Access Compliance Report

Public Rights-of-Way

(Pedestrian Signals)

Intersection ID: N/A	Main Street:	Cross Street: N/A	Location: N/A
ADA ID: FE7045522766	Signal Type: One Push Button-Non APS	Overall Compliance: No	Severity Score: BTN 1: N/A BTN 2: N/A No BTN: N/A
Codes/Mitigation Info/Possible Solution		Field Measurements/Component Compliance

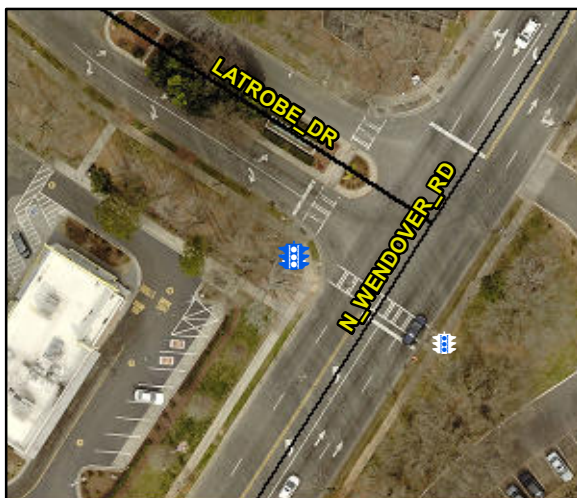
Compliance	Description	Data	Compliance	Description	Data
	Button Count	Button1	N/A	Distant to Additional Button (in)	N/A
	Additional Button Present?	No		Additional Button ID	N/A
N/A	Signal Buttons Required?	N/A	N/A	Additional Ped Posts Required	N/A
	How Many Ped Street Xings?	1		Located In An Island/Median?	No
N/A	B 1 Sign Present?	Yes	N/A	B 2 Sign Present?	N/A
Yes	B 1 Sign Purpose?	Yes	N/A	B 2 Sign Purpose?	N/A
Yes	B 1 Sign Lettering & Contrast?	Yes	N/A	B 2 Sign Lettering & Contrast?	N/A
No	B 1 Parallel To XWalk?	No	N/A	B 2 Parallel To XWalk?	N/A
Yes	B 1 PAR to Button?	Yes	N/A	B 2 PAR to Button?	N/A
Yes	B 1 PAR to XWalk?	Yes	N/A	B 2 PAR to XWalk?	N/A
Yes	B 1 Clear Floor Space?	Yes	N/A	B 2 Clear Floor Space?	N/A
N/A	B 1 FWD Approach?	Yes	N/A	B 2 FWD Approach?	N/A
N/A	B 1 FWD Approach Constrained?	No	N/A	B 2 FWD Approach Constrained?	N/A
No	B 1 FWD Approach Reach (in)	11.0	N/A	B 2 FWD Approach Reach (in)	N/A

N/A	B 1 FWD Approach Width (in)	N/A	N/A	B 2 FWD Approach Width (in)	N/A
N/A	B 1 FWD Approach Obstruction?	Yes	N/A	B 2 FWD Approach Obstruction?	N/A
N/A	B 1 FWD Approach Obstruction Dist (in)	8.0	N/A	B 2 FWD Approach ObstructionDist (in)	N/A
N/A	B 1 PARA Approach?	Yes	N/A	B 2 PARA Approach?	N/A
N/A	B 1 PARA Approach Constrained?	No	N/A	B 2 PARA Approach Constrained?	N/A
No	B 1 PARA Approach Reach (in)	11.0	N/A	B 2 PARA Approach Reach (in)	N/A
N/A	B 1 PARA Approach Width (in)	N/A	N/A	B 2 PARA Approach Width (in)	N/A
N/A	B 1 PARA Approach Obstruction?	Yes	N/A	B 2 PARA Approach Obstruction?	N/A
N/A	B 1 PARA Approach Obstruction Dist (in)	8.0	N/A	B 2 PARA Approach ObstructionDist (in)	N/A
Yes	B 1 Clear Floor Space Slope (%)	1.8	N/A	B 2 Clear Floor Space Slope (%)	N/A
No	B 1 Clear Floor Space XSlope (%)	5.6	N/A	B 2 Clear Floor Space XSlope (%)	N/A
N/A	B 1 PAR Slope (%)	2.1	N/A	B 2 PAR Slope (%)	N/A
Yes	B 1 Height (in)	39.0	N/A	B 2 Height (in)	N/A

Yes	B 1 Clear Xing Direction?	ClearlyMarked	N/A	B 2 Clear Xing Direction?	N/A
	B 1 Crossing Direction	To SE		B 2 Crossing Direction	N/A
Yes	B 1 DistanceTo XWalk (in)	0.0	N/A	B 2 DistanceTo XWalk (in)	N/A
No	B 1 DistanceTo Curb (in)	138.0	N/A	B 2 DistanceTo Curb (in)	N/A
Yes	B 1 Diameter (in)	2.0	N/A	B 2 Diameter (in)	N/A

Possible Solutions: Replace Signal Push Button With APS Button on New Post. Remove & Relocate Sign.

PROW/ADA: R209.1, TMUTCD 4e.08, R404.2, R406.2, R404.7.3
